RE: Commercial and Middle Street Mixed Use Development
Foundry Lane comments, responses & revisions

Enclosed please find a revised Conceptual Plan of J.B. Brown's proposed improvements to Foundry Lane. The proposal was revised to address a majority of staff's preliminary comments outlined in Jean Fraser's email to me on Monday, November 26th, 2012. I have included the comments below followed by a written response indicating how we will be addressing each comment.

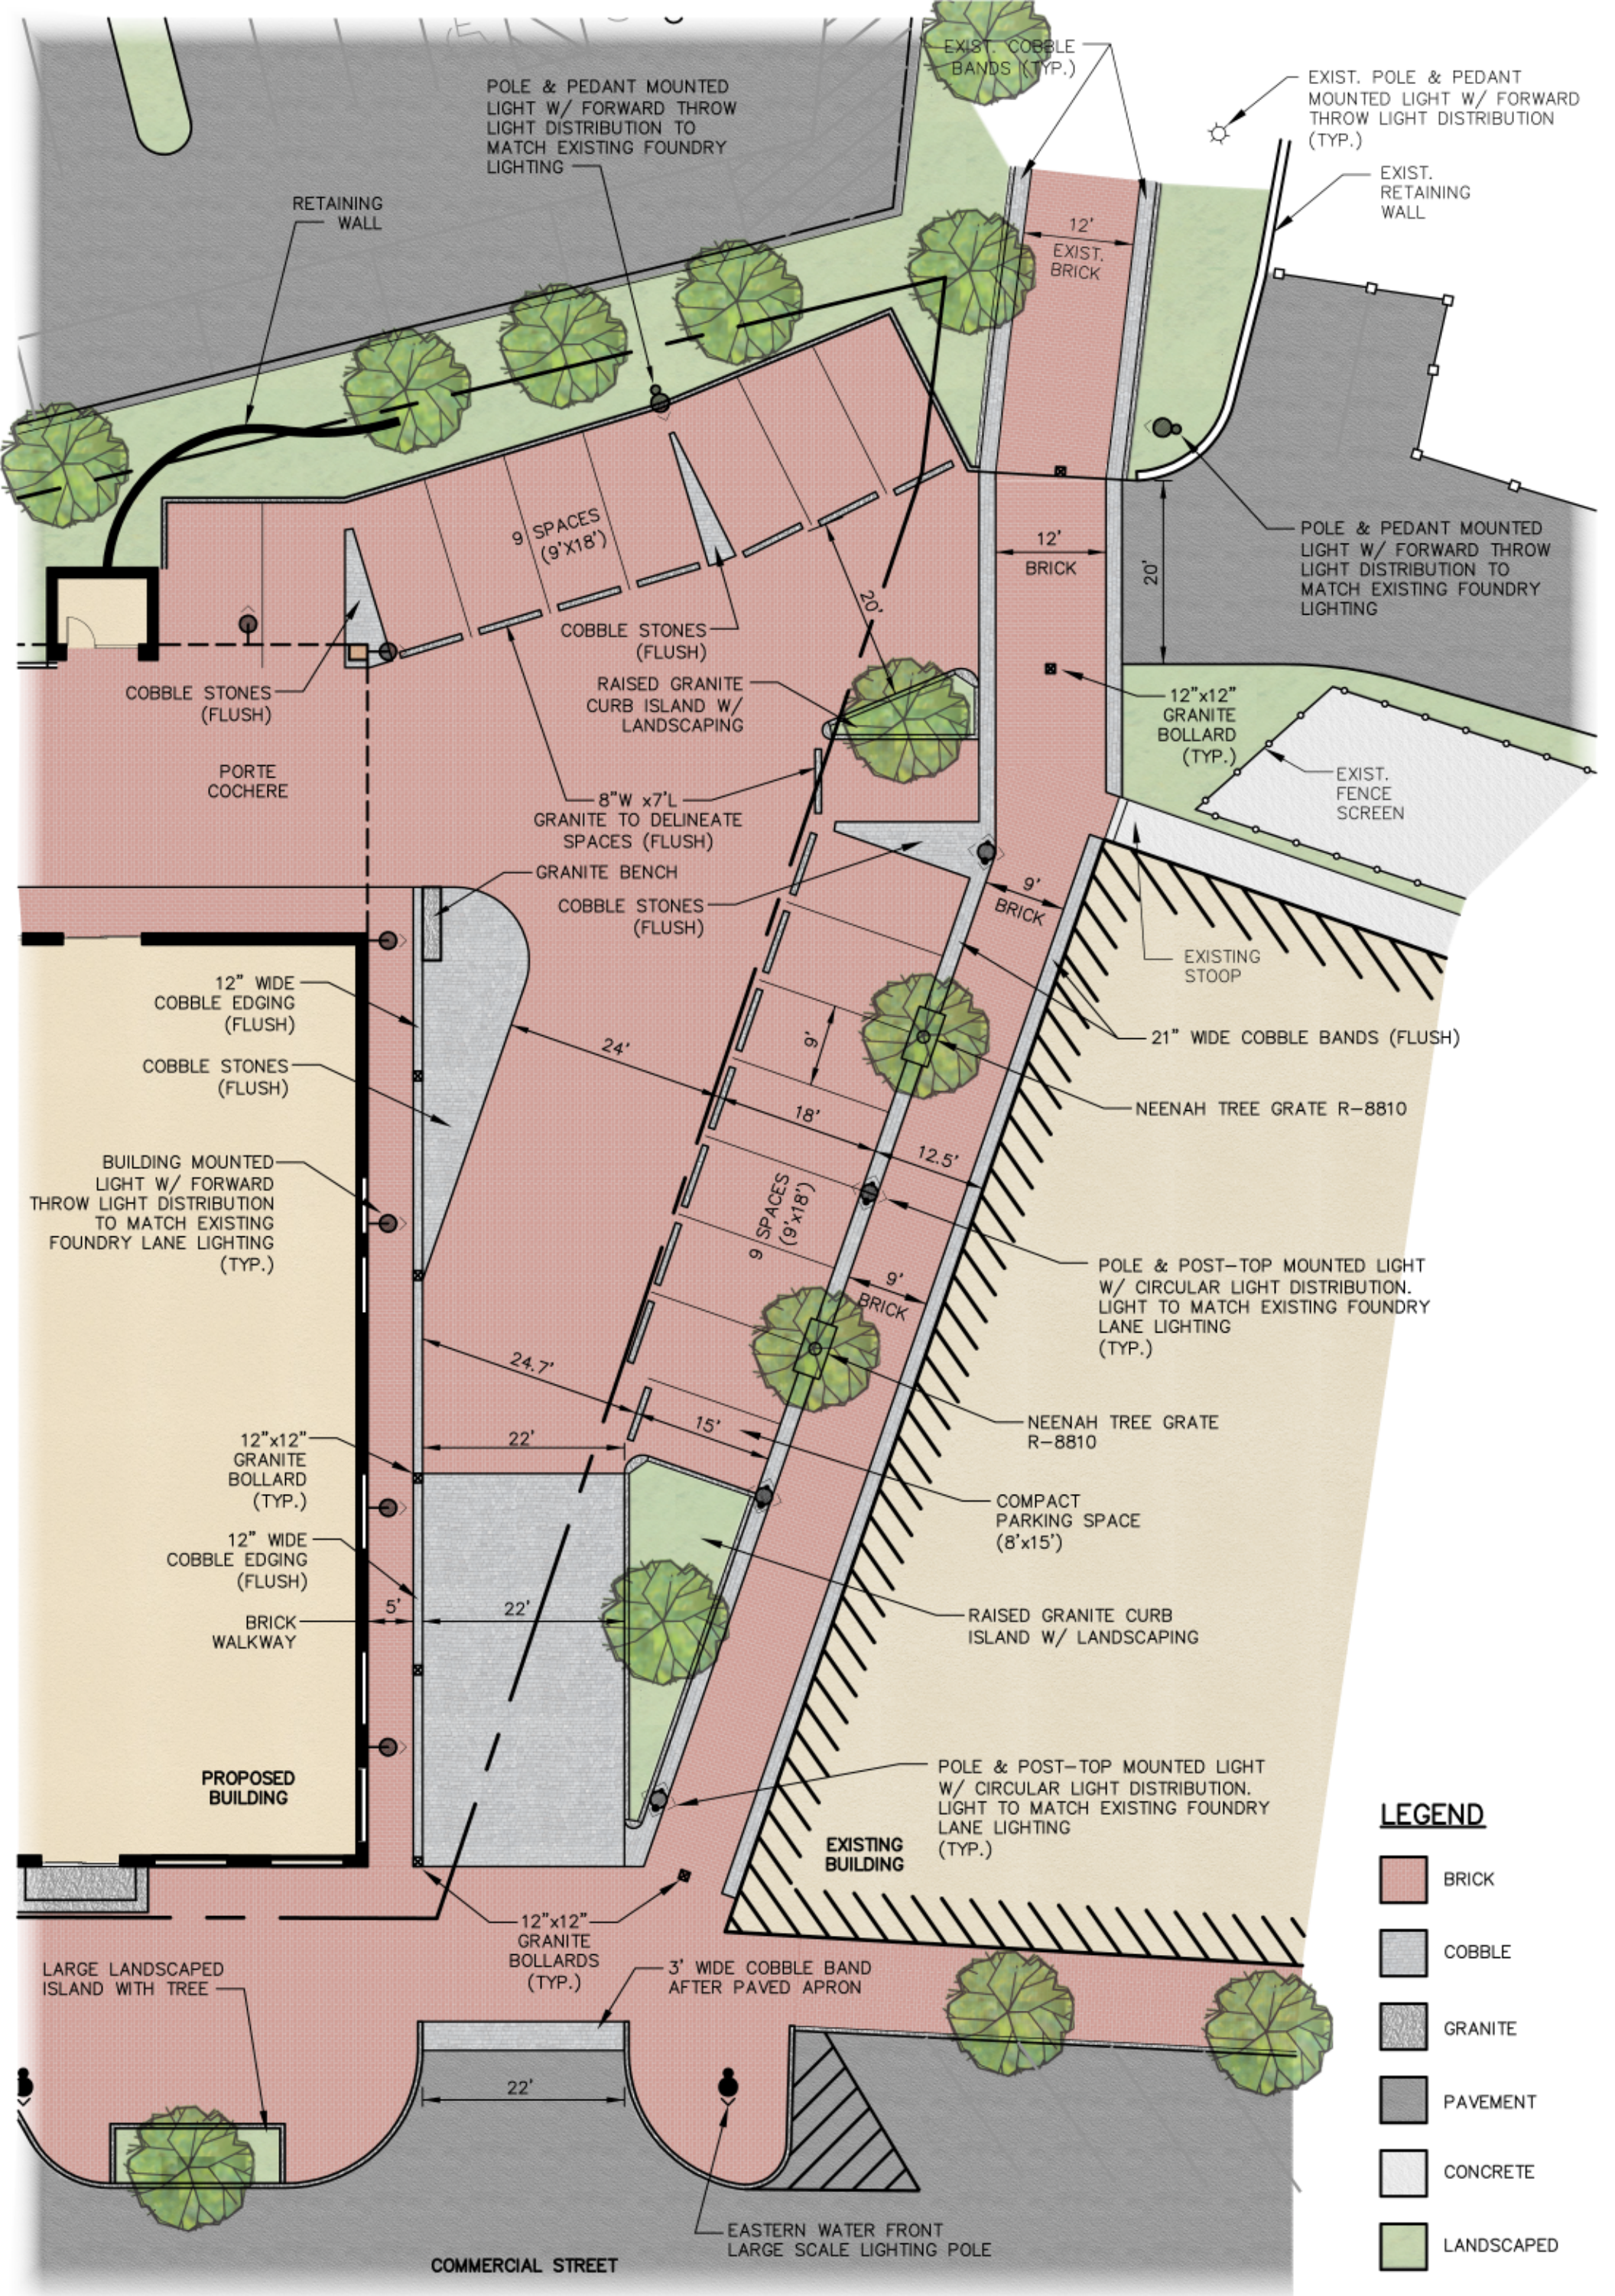
- The general concept is acceptable; the 22-foot entry width is acceptable. A few comments:
- The driveway at the location of the compact parking space is very tight. A vehicle parked in that space will extend out into the driveway and will reduce the effective width. A detail of this area illustrating how it will work is suggested.

- The applicant should provide a turning template for the three parking spaces where the parking aisle is only 18 feet wide. In general I think it is workable, but I'm not sure if the bollard is going to be a problem.

- Moving 2 of the trees along Foundry into the adjacent large triangular areas, with large planters to give them maximum room for soil and water; these areas suggested curbed with landscape rather than hard surface (Deb Andrews considers that the one nearest Commercial Street should be soft landscape edged with granite/cobbles for all of the triangular area, including the area of the bike racks, so that the 9 ft walkway section reads as a separate linear feature);

- Suggest a row of cobbles or granite stone at the back edge of each of the parking spaces (not continuous; one line of cobbles or linear stone for each space) would help delineate parking spaces and break up the expanse of brick (it is assumed there will be no striping)
 - ***We have implemented this revision.***
- Please specify the width of the cobble band along each side of the new section of pedestrian walkway and also along the existing section
 - ***A picture of the existing cobble bands below depicts 4 rows of cobbles running parallel with the brick walkway and generally a single cobble is 5" in the applicable dimension. With that said, the existing cobble bands are generally 21 or 22 inches in width. It is our intent to provide 4 rows of cobbles as the picture below. The Conceptual Plan depicts a 21 inch width for the proposed cobble bands.***

- Cobbles within Apron: I am waiting for confirmation from DPS that the cobbles are OK in the ROW - will get back to you but leave them in for now. Please specify width.
 - ***The Conceptual Plan depicts a 3 foot width. This will be approximately 7 rows of cobbles.***

- The original submitted plan for Foundry Lane (CO4, as submitted to Planning Board) showed 2 pole-mounted lights adjacent to the new walkway that gave light coverage to the new section of pedestrian walkway and continued the row of lights (see photo attached) that are along the existing walkway leading to York Street. I'm not sure the lights now proposed near the hotel will adequately light the central section of the new section of walkway and suggest some additional lighting should be incorporated to adequately illuminate the new section of the pedestrian walkway and address CPTED standards.

- ***The compact parking space is 15 feet in length as required and signage will be utilized to indicate compact cars only. Compact vehicles 15 feet in length or shorter will not extend into the parking aisle. To assist motorist in identifying parking space locations and length, we have added a flush granite stone "header" within the brick pavers. In addition, I have added parking aisle dimensions at this location to indicate a 22 feet at the aisle's most narrow width. This width will accommodate the turning maneuvers of a compact vehicle. A detail utilizing the turning template of a compact vehicle can be provided if the reviewer still deems it necessary.***

- ***The fire department has indicated they require 20 ft wide access roads. Thus we have revised this parking aisle width to 20 feet. In addition, the three parking spaces mentioned above are angled slightly provide smoother turning maneuvers in and out of the parking spaces along this one-way parking aisle. Further, two raised curbed islands have been added to the plan. One of the islands is in this location, and as a result, we have reduced the number of granite bollards and their location. The granite bollard specifically mentioned above has been deleted from the plan.***

- ***We have implemented this revision.***
- Two trees in between suggested to have "Neenah Tree Grate R.8801" as indicated in handwritten note (so that they will survive)

- ***We have revised the proposed lighting along Foundry Lane. The intent of the revisions is to use the lighting to further help Foundry Lane read as a separate linear feature to the driveway and walkway along the proposed building. In Foundry Lane, we are now proposing a rhythm of pole mounted lights and trees along walkway. The lighting mounted in a post-top configuration and will have circular distribution to equally illuminate the walkway and the parking spaces. Along the proposed building, we are proposing a rhythm of building mounted lighting with forward light distribution to illuminate the 5' walkway and driveway. Also, we are revising the light fixtures in this area to match the existing lights along the existing Foundry Lane to the northwest. The mounting of the lights will be different to better accommodate light distributions. Please see the below examples. A photometric plan will be provided to Planning pending the Historical Preservation Board's feedback.***
